**Village of Spring Valley
200 North Main Street
Spring Valley, New York 10977
845-352-1100**

**Planning Board Agenda
August 31st, 2020
7:00pm**

TO: Village of Spring Valley Planning Board
FROM: Michael D. Kauker, PP, AICP
Principal
DATE: August 28, 2020
SUBJECT: **13-15 Bethune Boulevard**
Review # 5

TO: Village of Spring Valley Planning Board
FROM: Michael D. Kauker, PP, AICP
Principal
DATE: August 31, 2020
SUBJECT: **14 Rose Avenue**
Review # 4

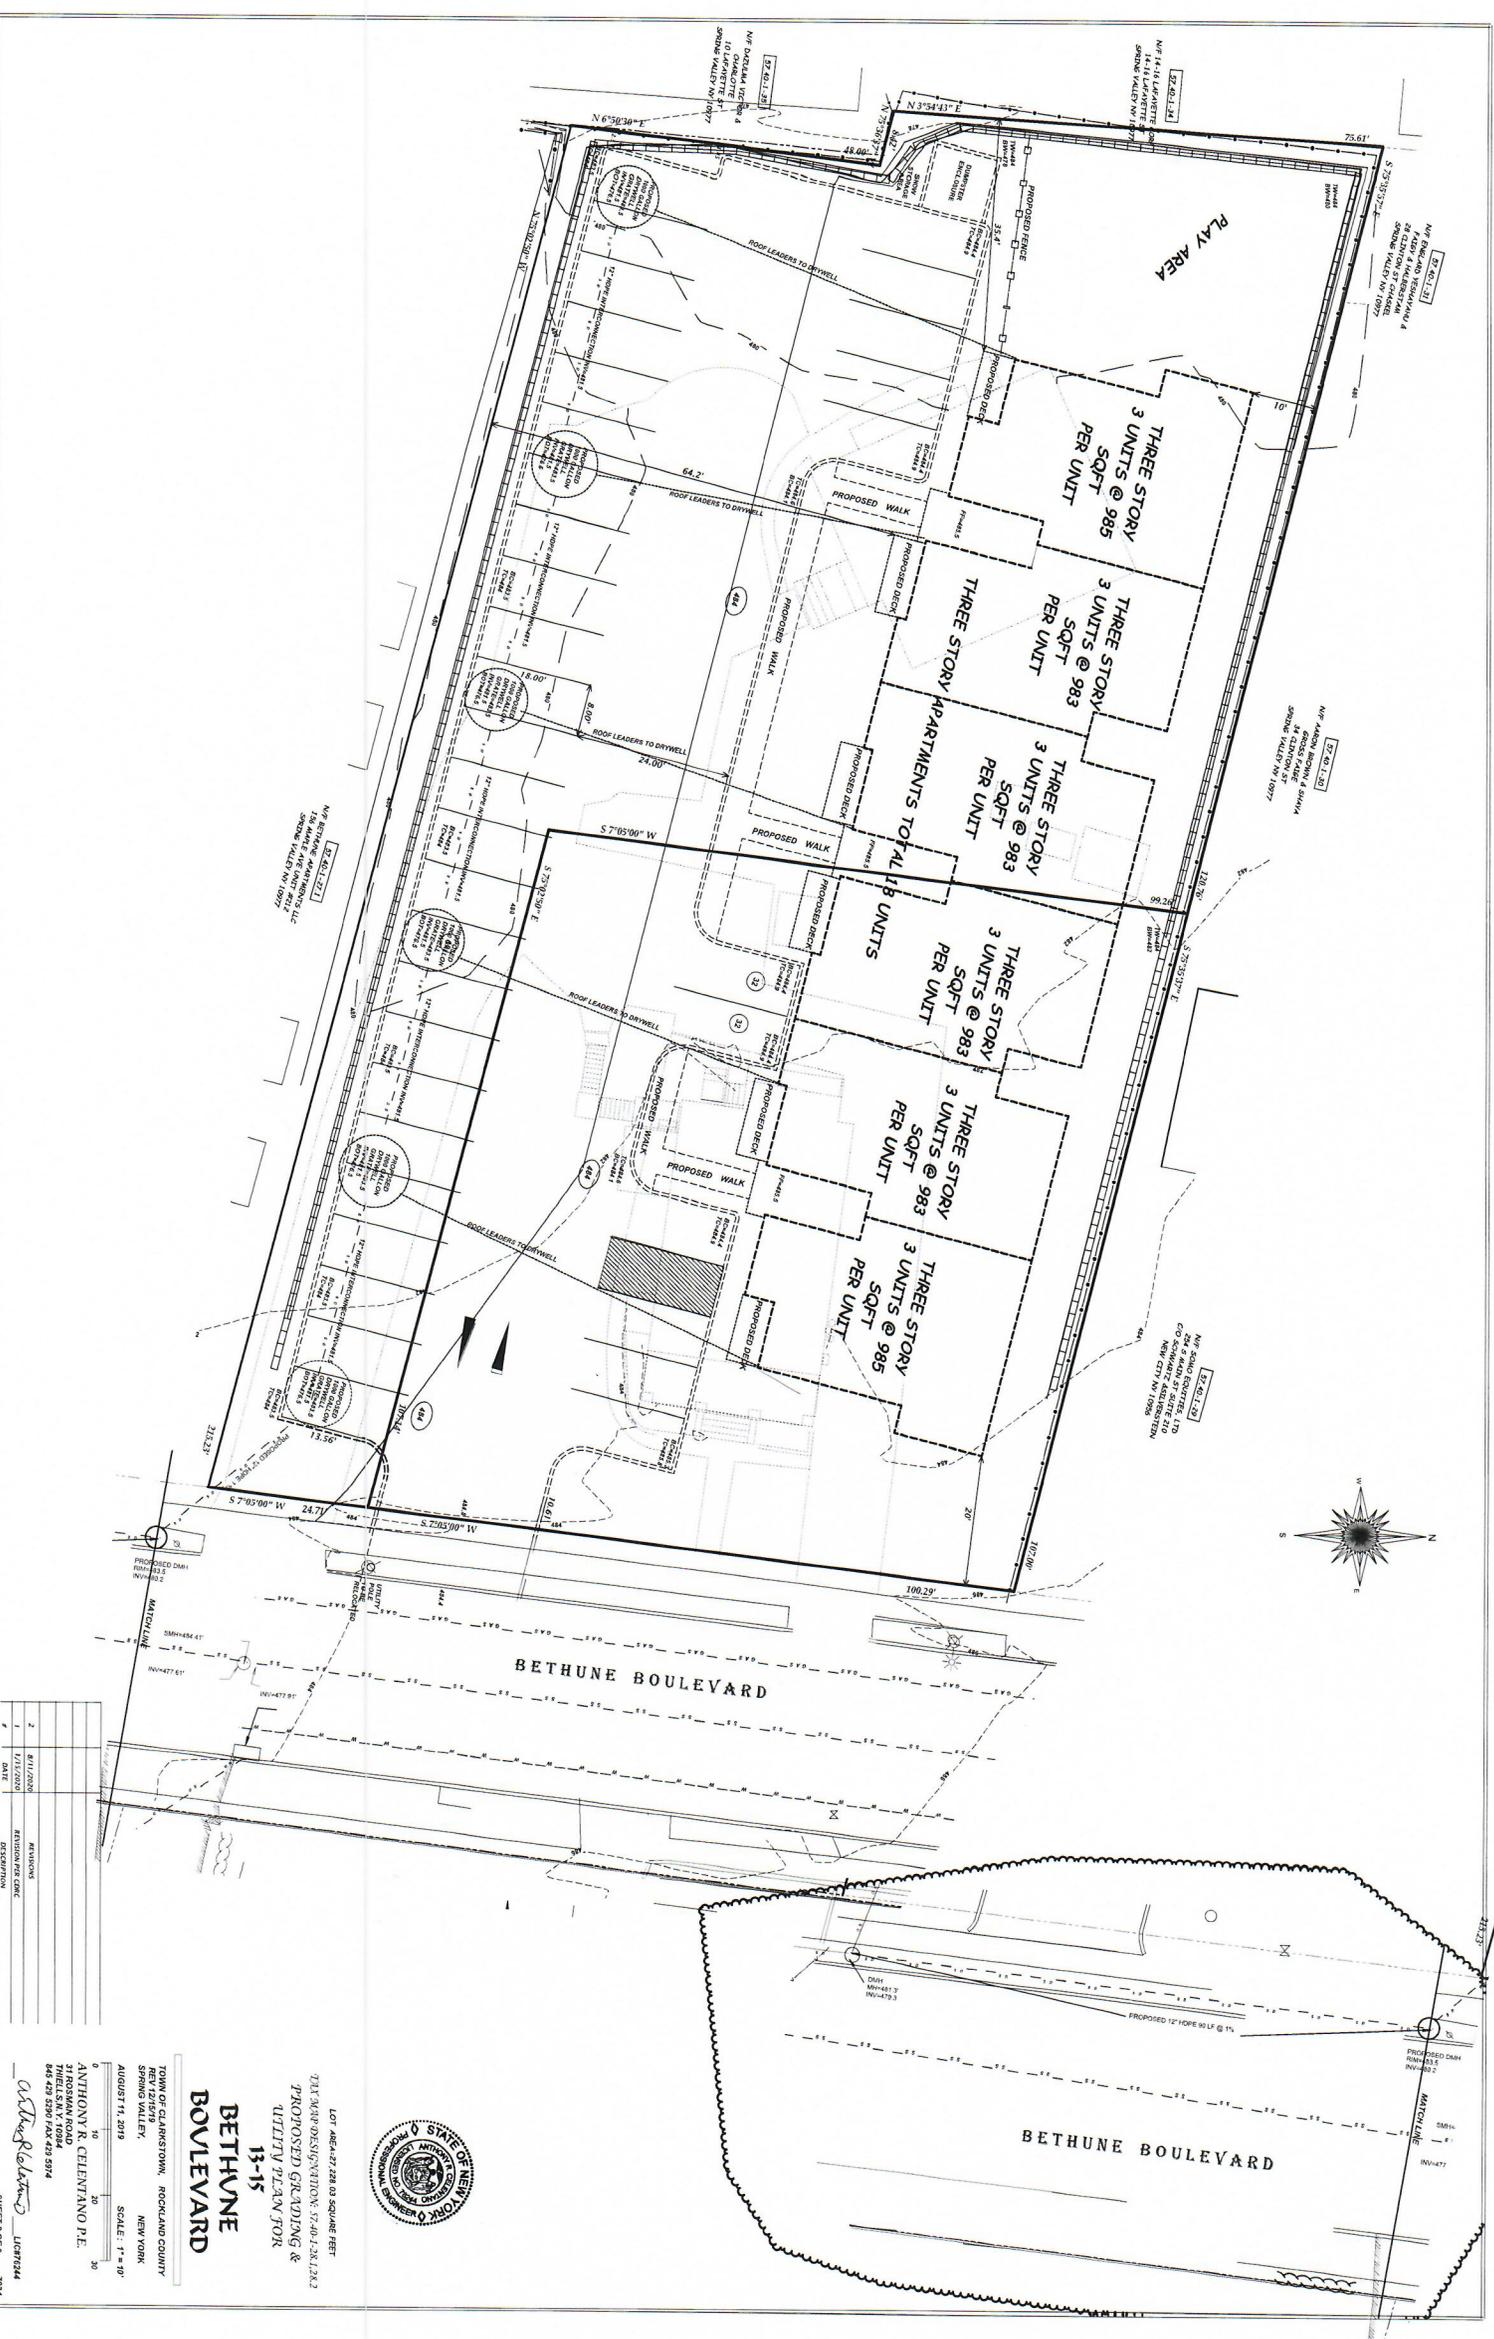
3. The proposed grading and existing conditions should only be shown on site plan sheets that relate to those elements. For example, they do not need to be provided on the planimetric plan or landscape and lighting plan among others.

LOT AREA 27,288 SQ SQUARE FEET
 7743 N 43RD DESIGNATION: S740-128-128.2
 PROPOSED L. LANDSCAPE
 & LIGHTING PLAN FOR
 13-15
BETHUNE BOULEVARD

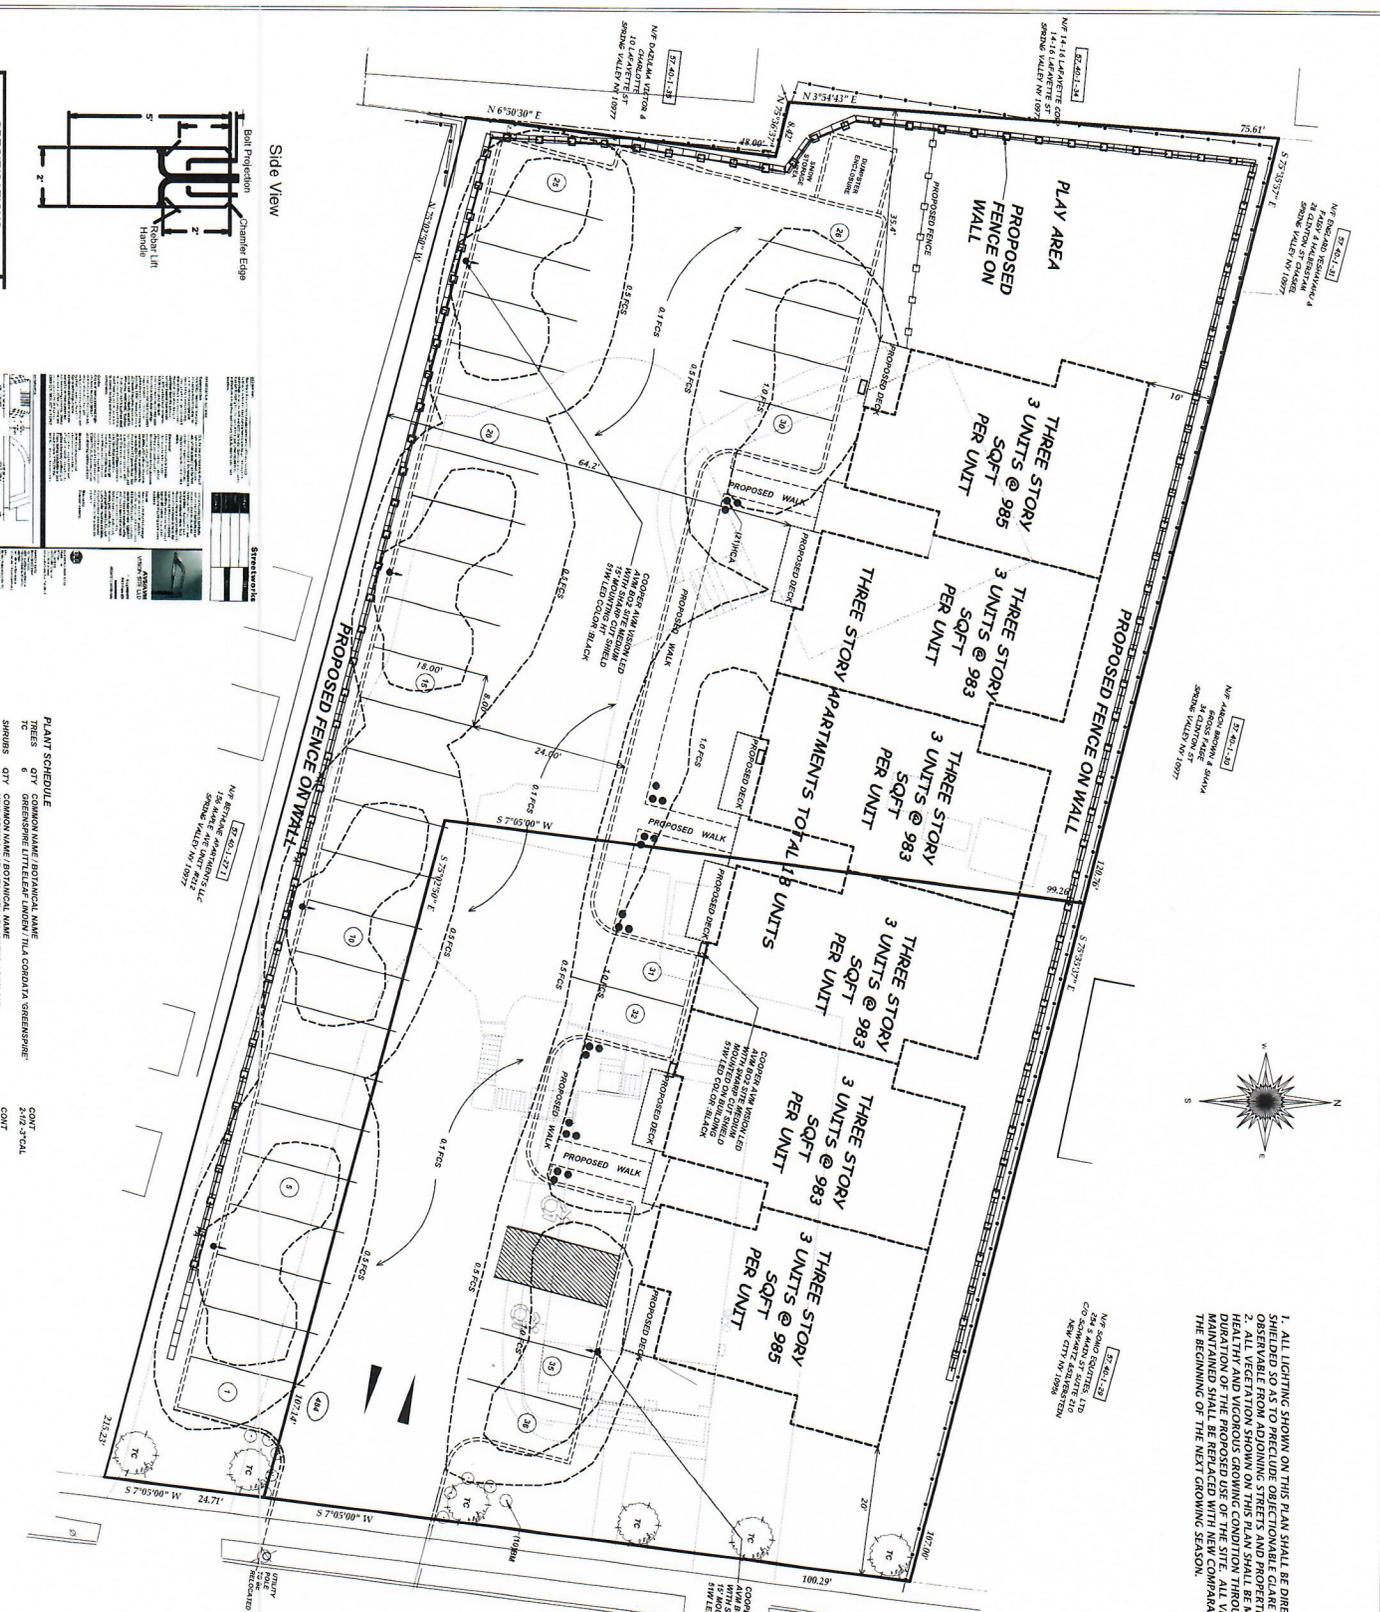
5. Additional landscaping should be provided in the front yard between the building and the street. I would recommend a berm with evergreen trees.
6. I would recommend a more residential type lighting fixture be provided.

1 **FIRST FLOOR PLAN**
 SCALE: 1/4" = 1'-0"

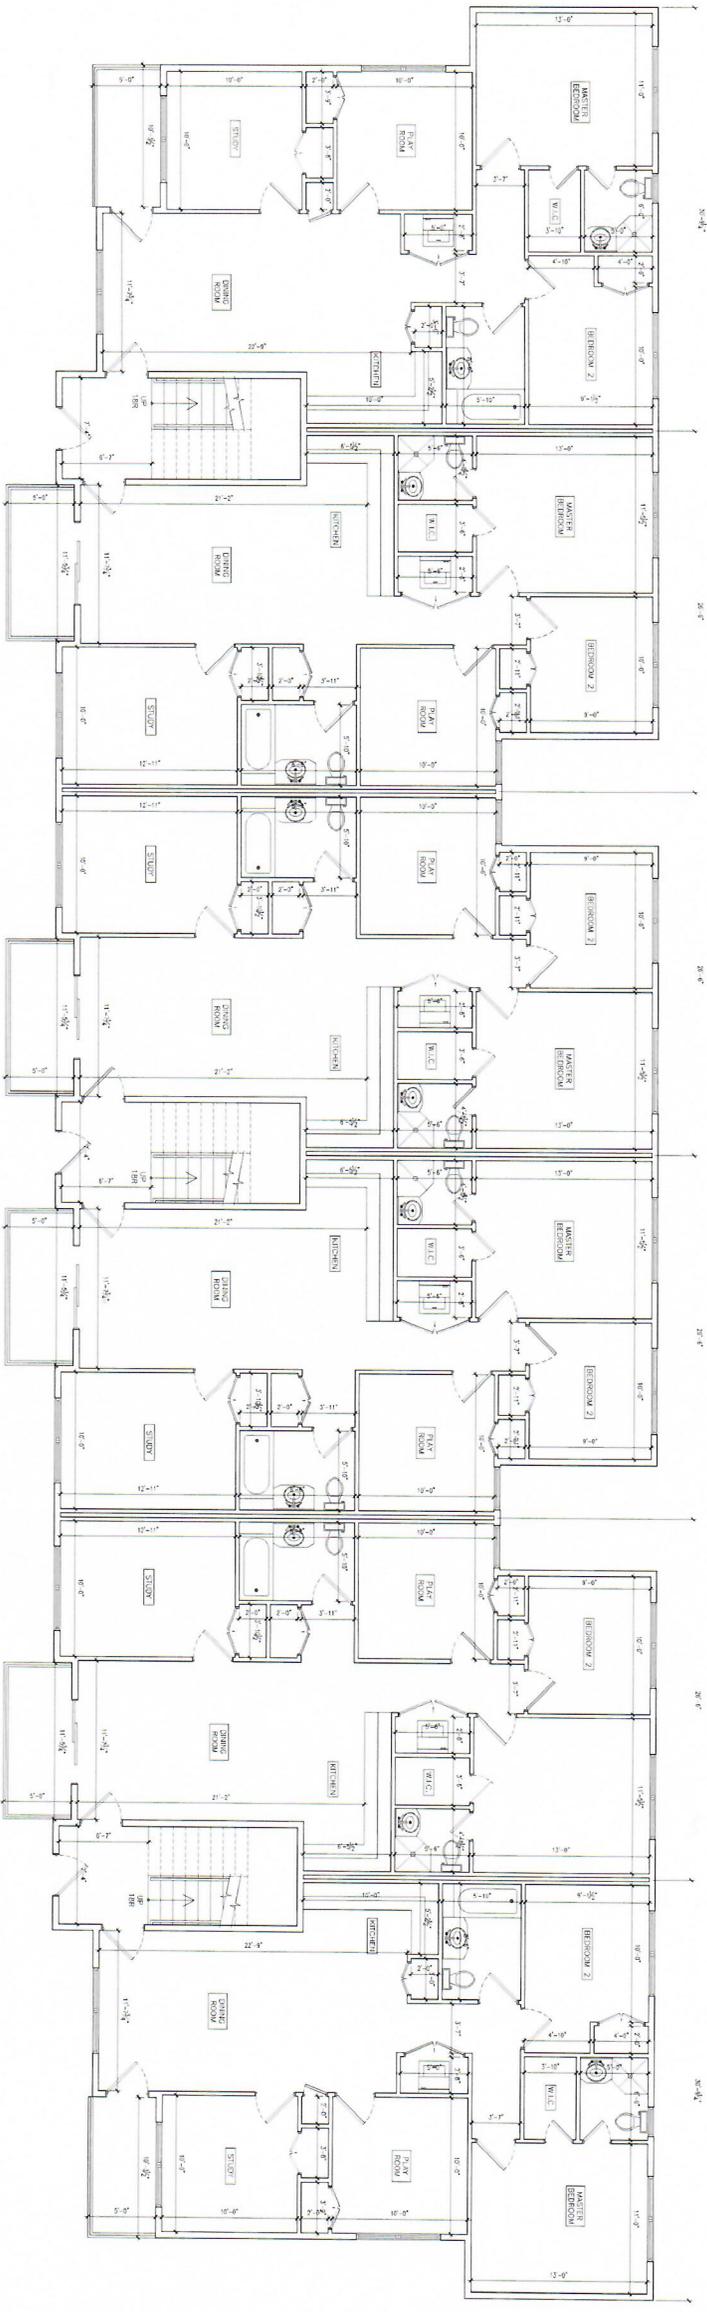
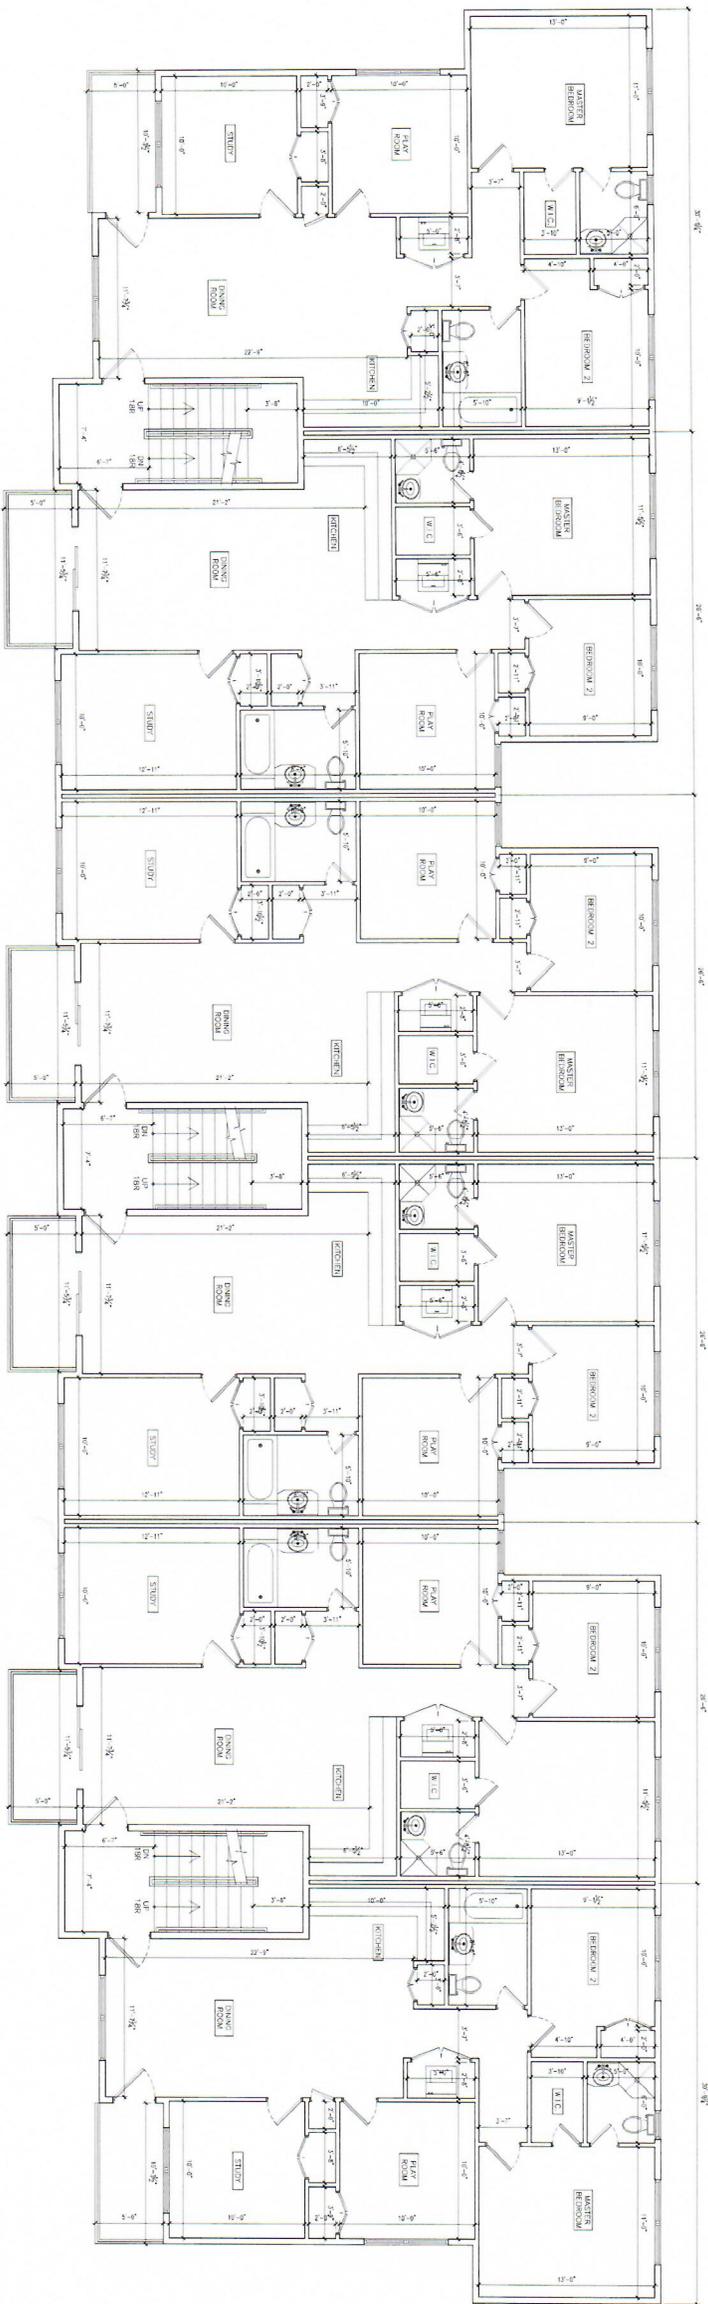
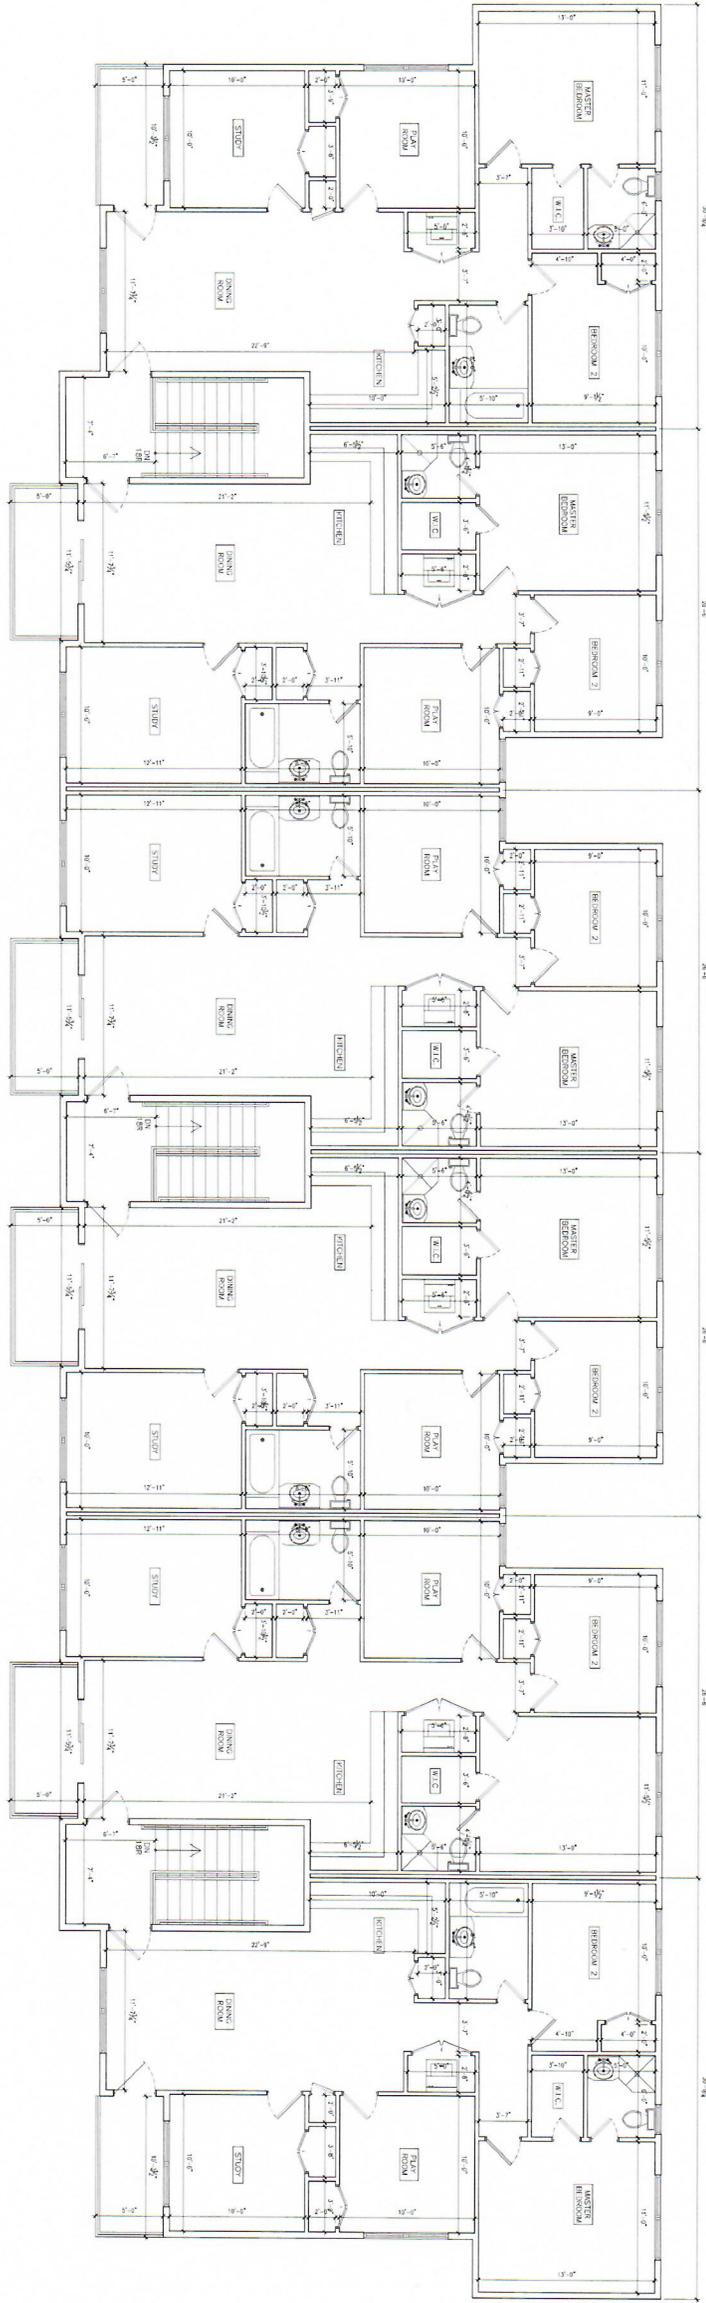
2. The building footprint on the site plan and architectural plans do not seem to match. This should be addressed by the applicant. Specifically, the front of the building shows two indents on the site plan where the architectural plans shows none.
